### ADDENDUM NO. 1

To the Drawings and Project Manual dated 16 June 2017

**TAS/ADA FIRE MARSHAL  
DEFERRED MAINTENANCE PROJECTS  
MIDWESTERN STATE  
UNIVERSITY**

Addendum Date: 2 August 2017

H-E101

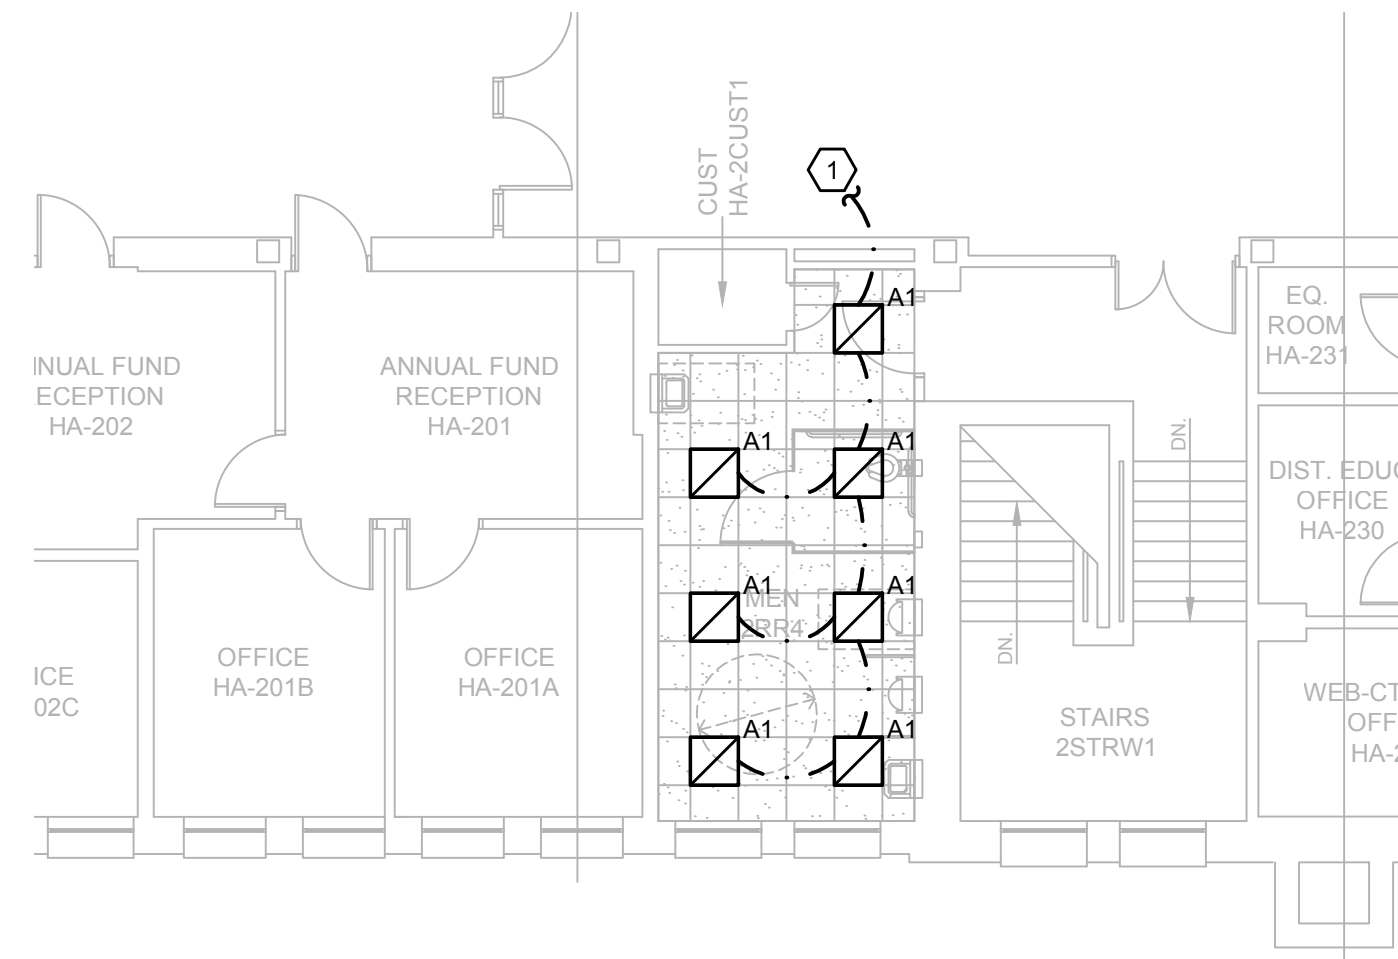
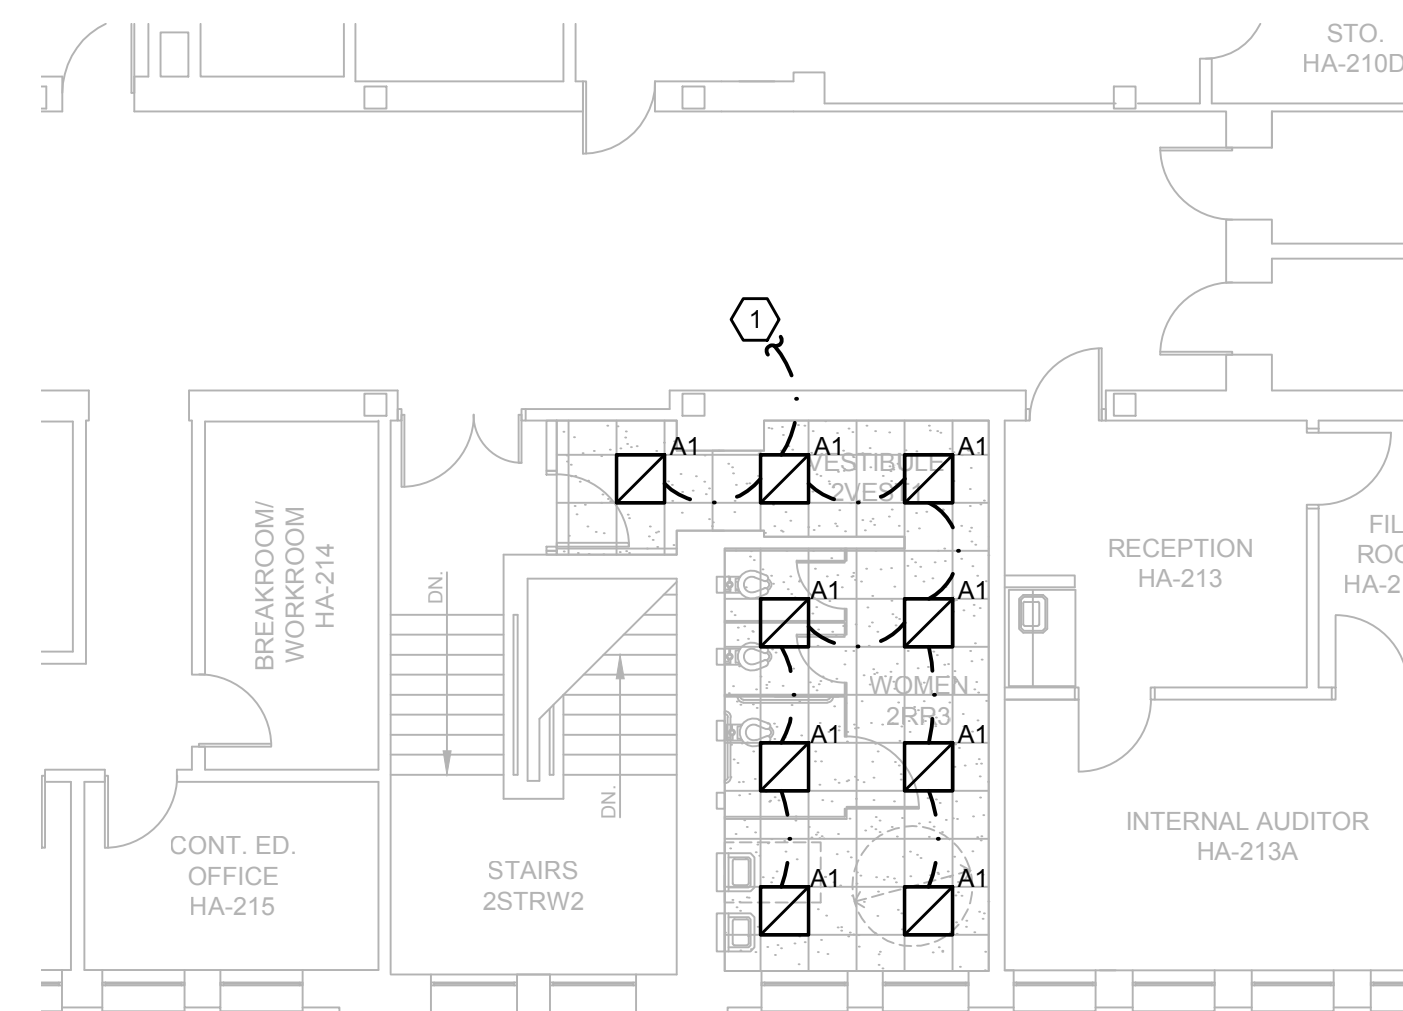
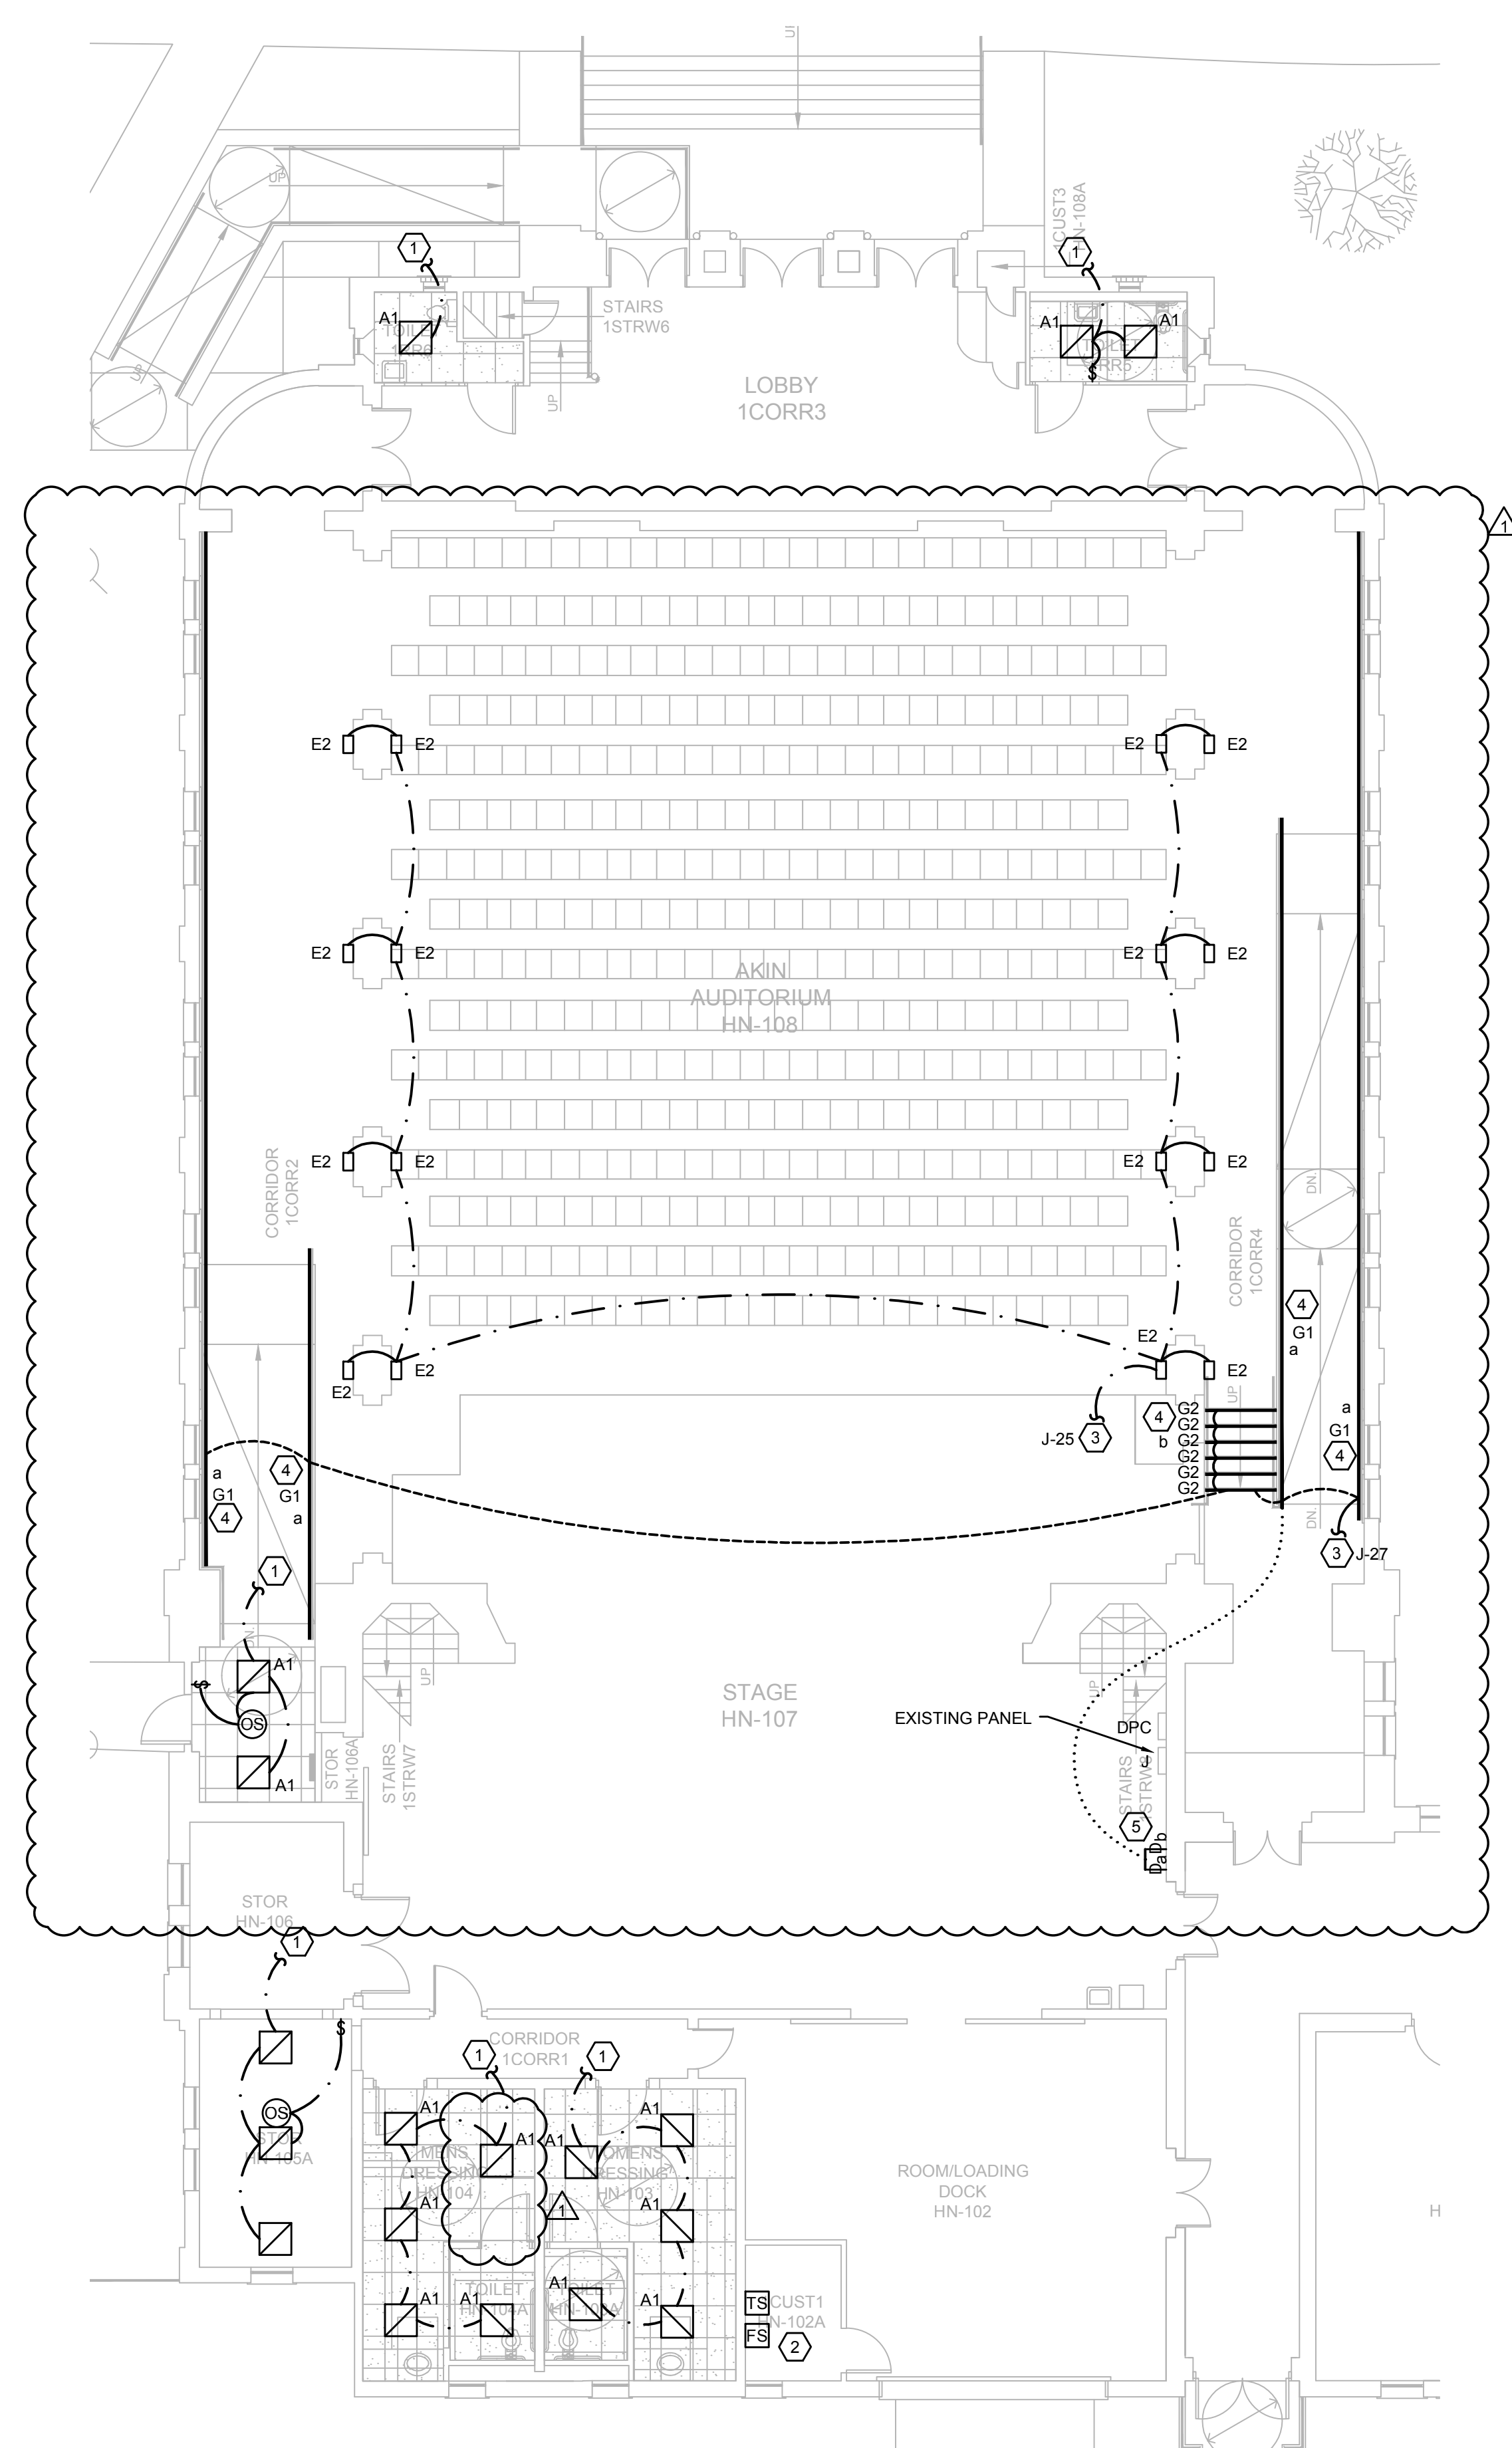
6. Sheet H-E101 – Revised Drawing as follows:
  - a. Adjusted lighting fixture in restroom to conform to architect's RCP.
  - b. Showed location of dimmers, existing panelboard, homerun circuits and corresponding changed in the Key Notes.

- c. Modified Lighting Fixture Schedule.
